Comparison of Innovative Housing Demonstration Projects with Typical Code Requirements

MEMORANDUM ADVISORY REPORT FINDINGS, CONCLUSION, AND RECOMMENDATIONS

File: DANIELSON GROVE FINAL SUBDIVISION, FILE FSB05-00001. The preliminary subdivision was approved with the Danielson Grove Innovative Housing Project, File No. S-IIB-03-92.

PROJECT NAME: Danielson Grove

ATTACHMENT 2
FSB05-00001

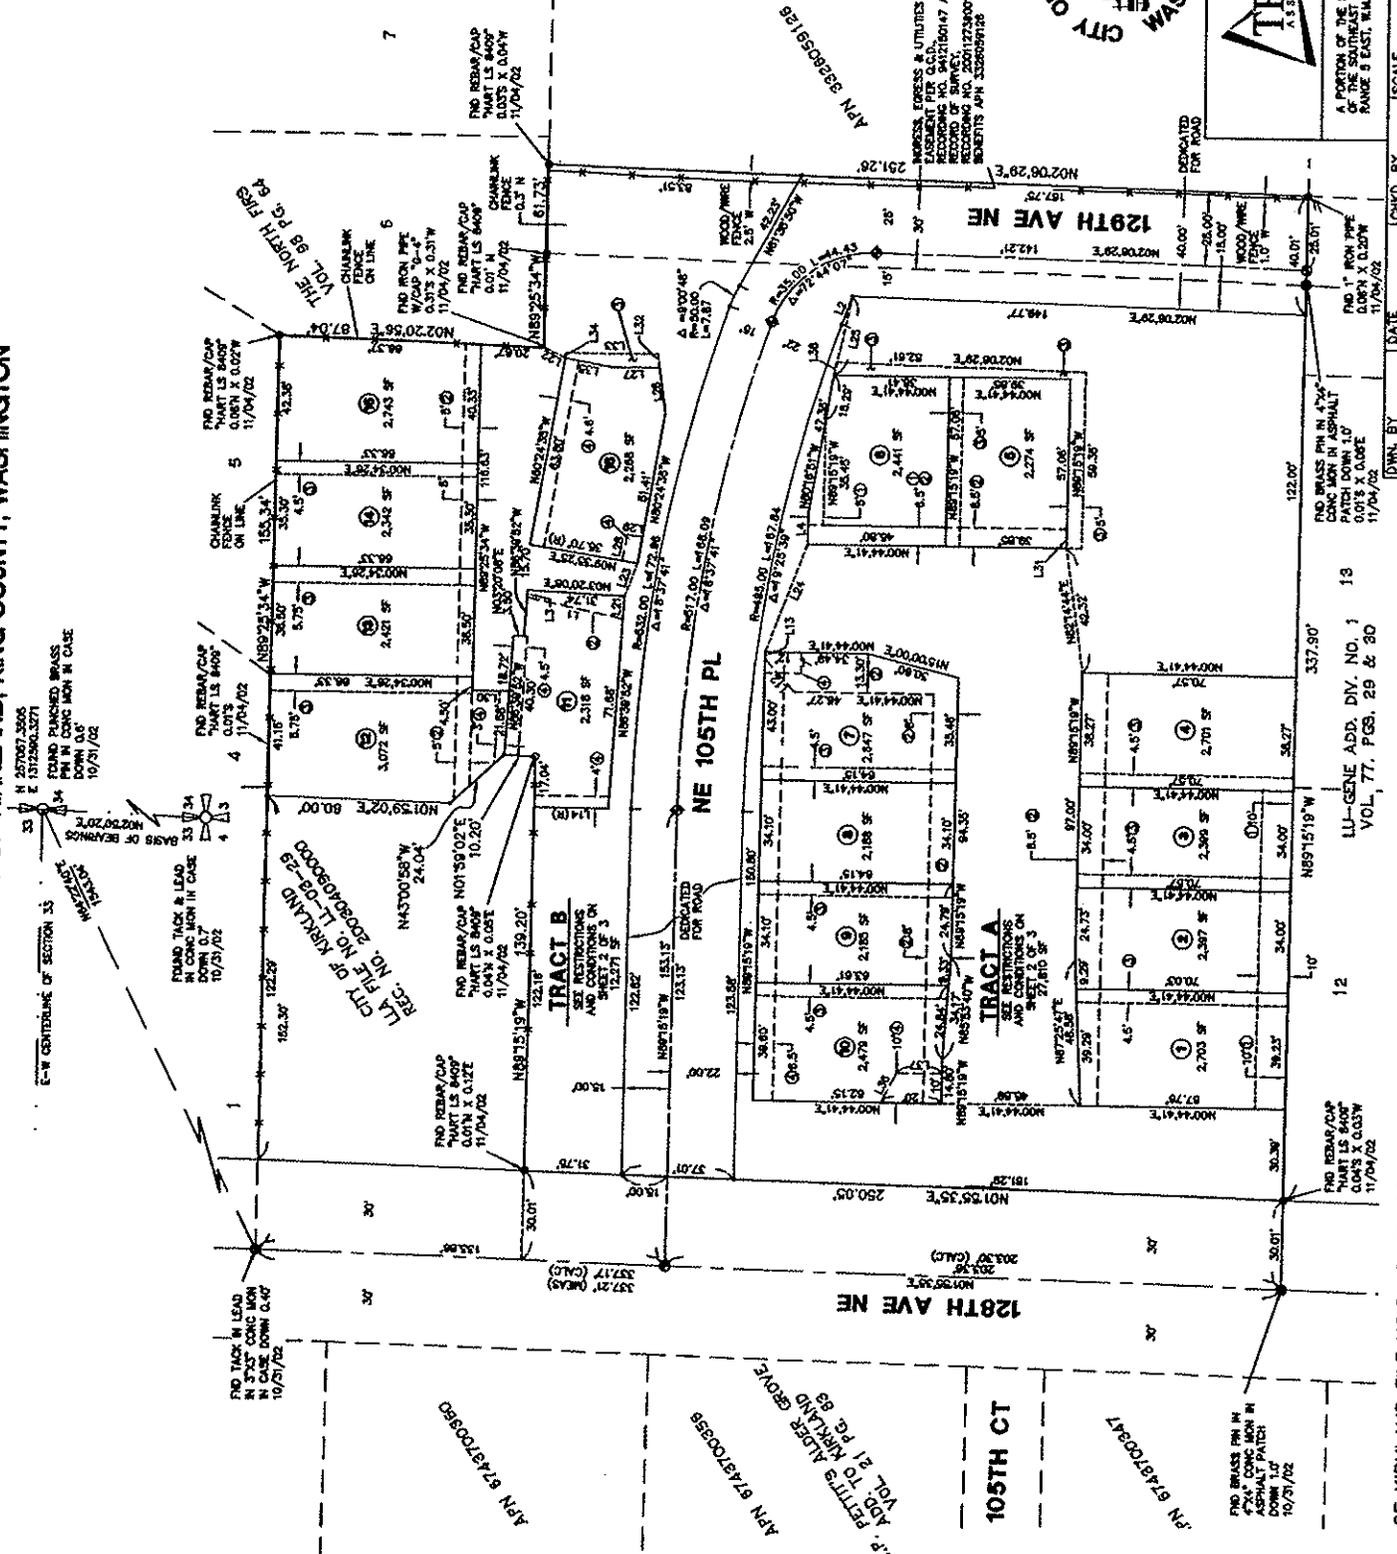
The applicant has proposed several minor modifications to the approved preliminary subdivision that meet the above criteria. The proposed revisions include:

1. A slight reduction of lot size for lots 5 and 12 is proposed. Both lots are decreased in size by less than the allowed ten percent. The remaining lots are all slightly larger than originally approved, except Lot 2 which remains the same size. There is not an increase in the number of lots originally approved and all of the lots are in the same location as originally approved. These minor lot size adjustments do not significantly alter the approved Preliminary Subdivision (See table below).
2. Note: Lots 5 and 6 of the approved preliminary plat were inaccurately shown to be 4,819 square feet each. The actual lot size for both lots is as shown below.

4. A slight adjustment in the size and shape of the open space tracts have been made to accommodate the above lot size adjustments, and other associated conditions of preliminary approval. All of the open space tracts are in the same location as originally approved. The proposed changes do not significantly alter the approved Preliminary Subdivision.
